# **MAXWELL ADULT CENTER EXPANSION**

# CHANGE PROPOSAL SUMMARY

#### PROPOSAL REQUEST BRINKLEY SARGENT WIGINTON ABCHITECTS Distribution: OWNER X ARCHITECT X CONTRACTOR X CONSULTANT **Maxwell Center Expansion** PROJECT: PROPOSAL REQUEST NO.: 02 1201 Center Street Deer Park, Texas 77536 OWNER: City of Deer Park DATE: December 19, 2017 TO: Frost Construction Company **BSW PROJECT NO.:** 21603.02 19506 Hwy 59 North, Suite 220 Humble, Texas 77338 **CONTRACT FOR: General Construction CONTRACT DATE:** October 3, 2017 Please submit an itemized quotation for changes in the Contract Sum and/or Time incidental to proposed modifications to the Contract Documents described herein. Item No. 1. Remove all drywall from perimeter walls of the original tilt-up construction. Remove related insulation and furring strips. Remove all water and termite damaged interior partition assemblies. Remove all mold, mildew & termite paths. Refer to attached field mark-up for extent of work. Item No. 2. At current exterior walls (north, west and south) of existing tilt-up construction, provide new/replaced backer rod and sealant on interior side of all tilt-wall panel joints. Then provide new vapor barrier, furri

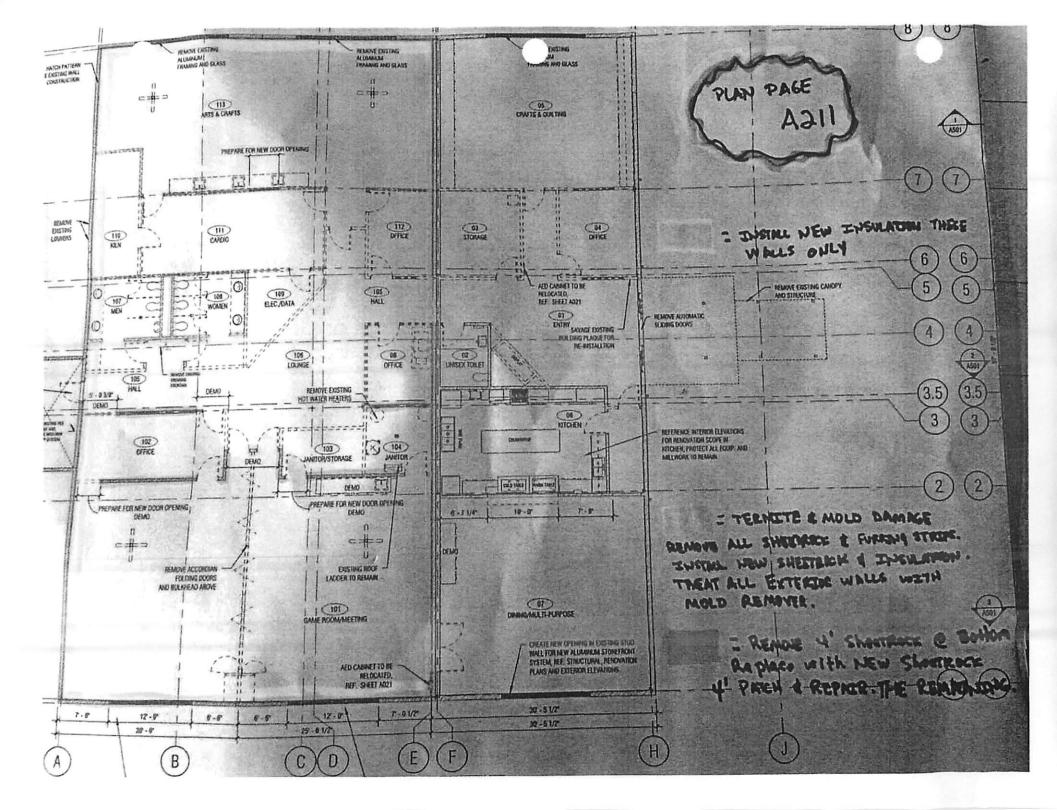
Item No. 4. Replace damaged interior partitions as described on field mark-up.

deck where no ceiling is indicated.

Item No. 3.

At eastern tilt-wall construction (along Grid E), provide new furring & drywall similar to Item 2. Vapor barrier and insulation are not required along this grid line. This assembly shall be continuous from floor to 6" above ceiling, or to

\*Note: Installation of new insulation and drywall shall occur after completion of the new roof.
